TECHNICAL BULLETIN

FAM-A-0063-A

Change in Packaging for the FX5UJ CPU Modules

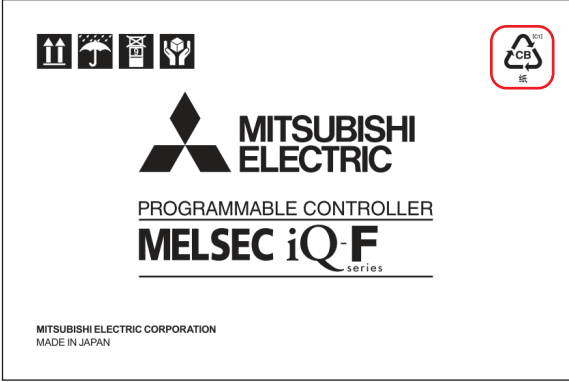
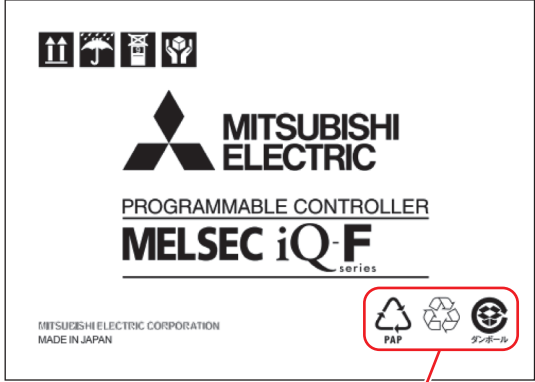
The form of the packaging box is changed as follows to remove molded pulp buffer materials and polyethylene bags.

Before change	After change
 <p>Molded pulp buffer material Polyethylene bag</p>	
 <p>MITSUBISHI ELECTRIC PROGRAMMABLE CONTROLLER MELSEC iQ-F series</p> <p>MITSUBISHI ELECTRIC CORPORATION MADE IN JAPAN</p>	 <p>MITSUBISHI ELECTRIC PROGRAMMABLE CONTROLLER MELSEC iQ-F series</p> <p>MITSUBISHI ELECTRIC CORPORATION MADE IN JAPAN</p> <p>Changed recycling codes</p>
